## COUNCIL ASSESSMENT PANEL MEETING

### AGENDA – 8.5

<b>Applicant:</b> Sasha & Gary Holland	<b>Landowner:</b> S J L & G L Holland
<b>Agent:</b> Philip Harnett (URPS)	<b>Originating Officer:</b> Damon Huntley
<b>Development Application:</b>	20/1198/473
<b>Application Description:</b> Two storey detached dwelling, deck (maximum height 4.12m), combined fence & retaining walls (maximum height 3.4m), swimming pool & associated barriers, masonry fence, associated earthworks & landscaping	
<b>Subject Land:</b> Lot:50 Sec: P2797 DP:111446 CT:6175/564	<b>General Location:</b> 9 Braemar Terrace Stirling  <b>Attachment – Locality Plan</b>
<b>Development Plan Consolidated:</b> 08 August 2019 <b>Map</b> AdHi/28 & AdHi/72	<b>Zone/Policy Area:</b> Country Living Zone - Country Living (Stirling And Aldgate) Policy Area
<b>Form of Development:</b> Merit	<b>Site Area:</b> 771 m <sup>2</sup>
<b>Public Notice Category:</b> Category 2 Merit	<b>Representations Received:</b> 6  <b>Representations to be Heard:</b> 4 (previously heard)

## **Development Application 20/1198/473 – 9 Braemar Terrace, Stirling.**

**SITE PLAN - UPPER**  
SCALE 1:200

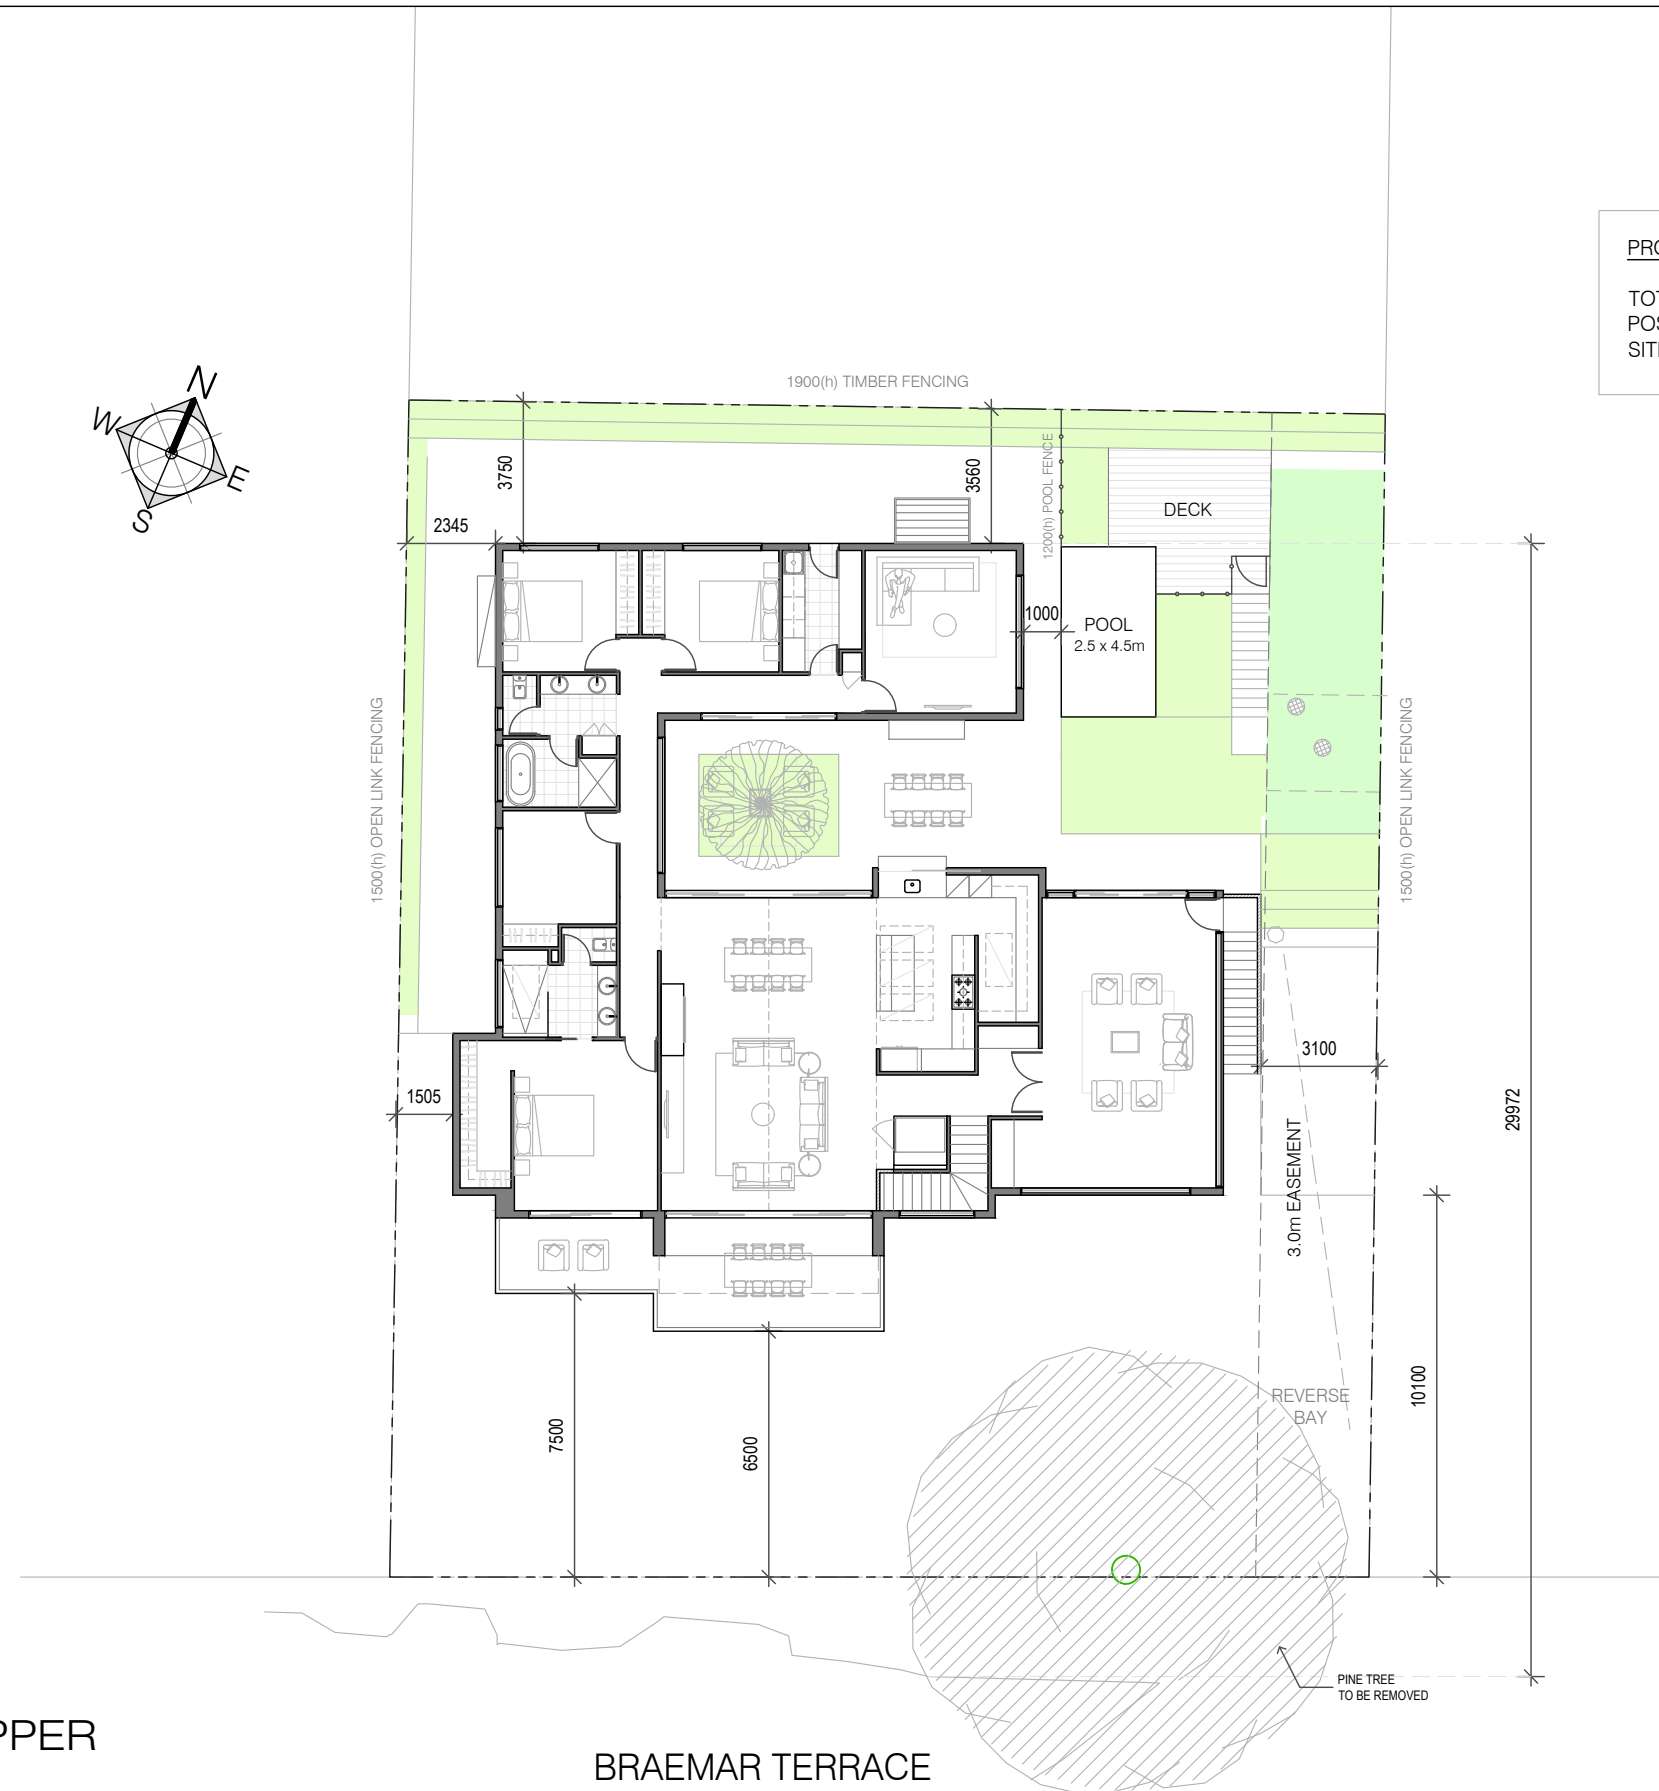
**(2) The building set-back to the western boundary**

The Applicant has amended the design of the dwelling to incorporate a greater set-back distance from the western boundary. The table below outlines the design alterations relating to the minimum set-back distance to the side boundary (refer to the change of dimensions listed in the column labelled 'Drawing 02 of 07 Rev F'):

<b>Drawing 02 of 07 Rev E</b>	<b>Drawing 02 of 07 Rev F</b>
<b>Minimum set-back distance</b>	1.005m	1.505m
<b>Length of subject wall</b>	4.3m	4.3m

As demonstrated in the table above, the minimum set-back distance of the western wall has been reconfigured from 1.005 metres to a set-back distance of 1.505 metres (i.e. a 50% increase).

It is noted that the western wall of the dwelling is a maximum height of 6.5 metres, measured from natural ground level below. It is noted that the western wall of the dwelling only exceeds 6 metres across 2.7 metres of wall length. The remaining 14.9 metres of the western wall ranges between a maximum height of 6 metres (measured above natural ground level), and a minimum of 3.3 metres (measured from finished ground levels).

In terms of side set-backs, a depth of 13.6 metres of the western wall does not meet the 3 metre set-back distance sought by PDC 9 (Country Living Zone), but does comply for 4.1 metres of the wall length.

It is noted that 76% of the total western wall does not meet to the set-back requirements of PDC 9, and the area of wall breaching the desired set-back parameter forms a depth of 43% of the total side boundary length of the allotment. While an additional side set-back distance of 0.5m to 1m would bring the design closer to the desired side set-back parameters of PDC 9, regard has been given to the limited site area of the subject land, and the area of the site for which is suitable to accommodate the footprint of the dwelling.

It is noted that the adjoining site at 7A Braemar Terrace is currently a vacant allotment, and as a result, the maximum height of the wall will not give rise to any overshadowing. It is noted that the side set-back requirements are achieved on the eastern flank of the dwelling. When considered on balance, the design shortfall against the setback guidelines in PDC 9 does not warrant refusal of the application.

The applicant has amended the walk-in-robe extending from bedroom 1 to increase the setback from the western boundary by 500 millimetres, to be 1.5 metres.

The remainder of the dwelling is setback at least 2.3 metres from the western boundary and largely has a single storey height as the natural ground level ascends.

The 1.5 metre setback now proposed has a total length of 4 metres which is insignificant given the total length of the western boundary is 31.1 metres and substantial space features around all other elevations of the dwelling.

## FLOOR PLAN - UPPER

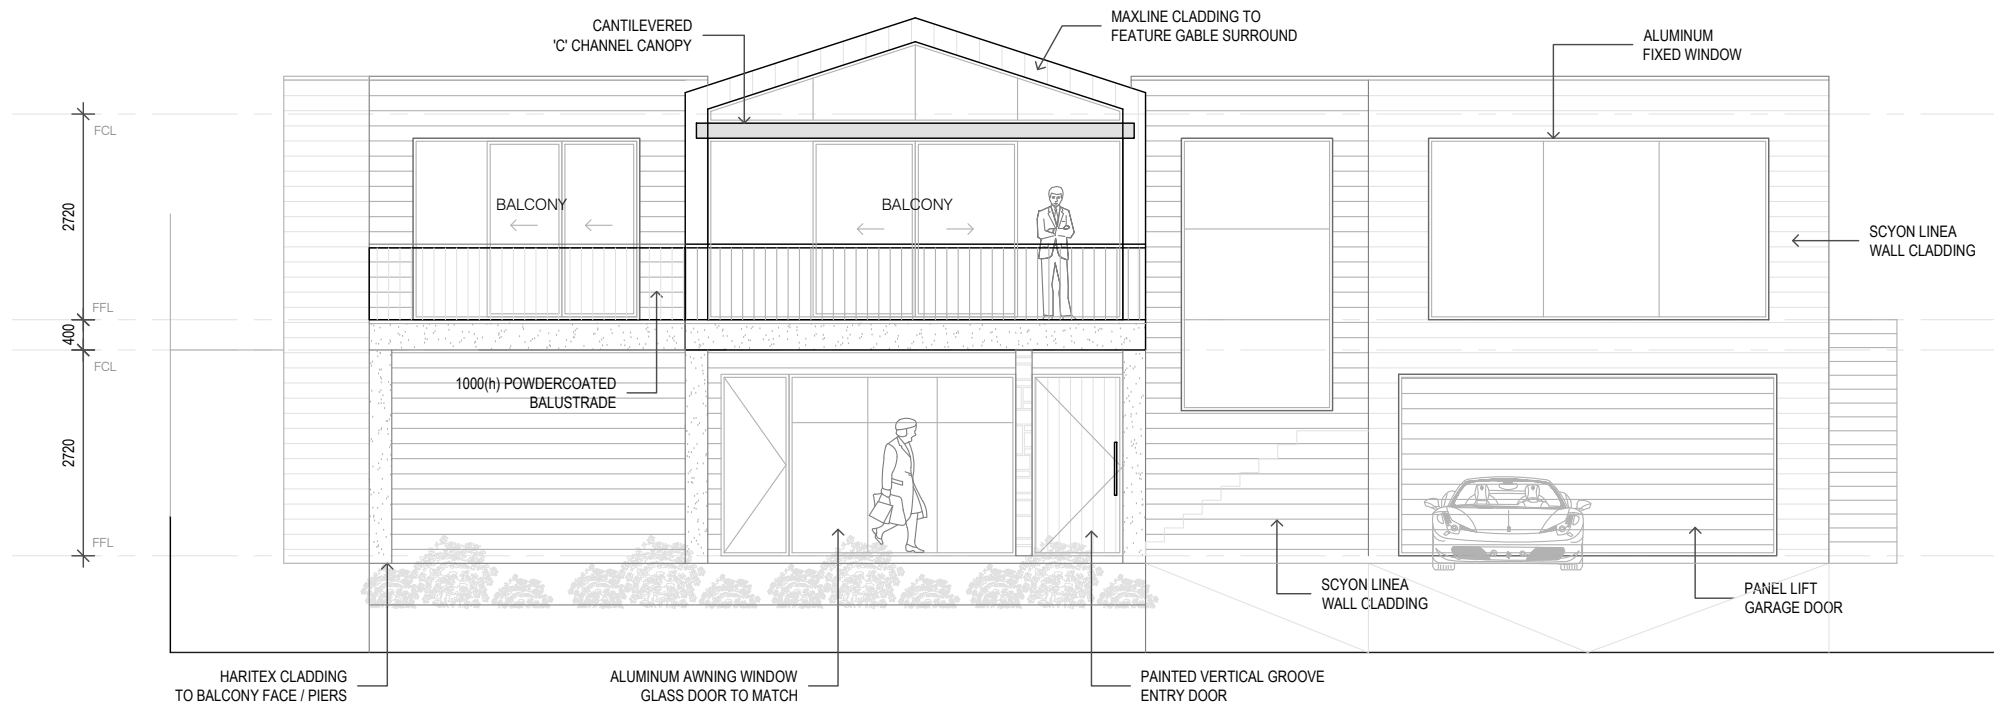
### (1) The scale of the front balcony and level of intrusion into the streetscape

During the Council Assessment Panel meeting of 12 May 2021, the Panel considered that the overall size and scale of the front balcony would form a highly prominent feature of the dwelling, and determined that the element would form an intrusive component of the building when viewed within the immediate streetscape.

In response to the matter raised by the Panel, the Applicant has amended the design of the balcony positioned at the front of the proposed dwelling. The table below provides an overview of the design alterations relating to the balcony (refer to the change of dimensions listed in the column labelled 'Drawing 04 of 07 Rev F'):

Drawing 04 of 07 Rev E	Drawing 04 of 07 Rev F
<b>Depth</b>	4m (maximum) 3.5m (minimum) 3m (cantilevered canopy above)	3m (maximum) 2m (minimum) 2m (cantilevered canopy above)
<b>Width</b>	10.3m 5.8m (cantilevered canopy above)	10.3m 5.8m (cantilevered canopy above)
<b>Total Area</b>	39.03m <sup>2</sup>	26.6m <sup>2</sup>

As illustrated in the table above, the set-back distance of the primary balcony (from the living area) has reduced by a depth of 1 metre (i.e. 25%), and the set-back distance of the secondary balcony (from bedroom 1) has reduced by a depth of 1.5 metres (or 43%). The canopy projection cantilevered above the primary balcony has reduced from 3 metres to 2 metres. The change of dimensions to the total balcony area amounts to a reduction in the order of 32%.

It is noted that the main building line of the dwelling complies with the 8m minimum front setback requirement as desired by PDC 9 (Country Living Zone). However, it is acknowledged that the upper-level balcony does intrude within the 8m set-back area between the main face of the dwelling and the front boundary of the property. From the front boundary of the site, the balcony would be set-back a minimum distance of 6.5 metres, to a maximum of 7.5 metres.

Whilst the balcony is positioned within the 8 metre separation distance sought by PDC 9, the reduced set-back distance of the balcony is considered to be acceptable as the balcony forms an open profile, offering visual permeability to the principle elevation of the dwelling.

The applicant has made the following amendments to reduce the intrusion of the front balcony into the streetscape:

- Increased the setback of the primary balcony (from the living room) by 1 metre.
- Reduced the canopy projection over the primary balcony by 1 metre.
- Increased the setback of the secondary balcony (from bedroom 1) by 1.5 metres.

This has meant that the scale of the balcony has also reduced substantially, particularly that which extends from bedroom 1.
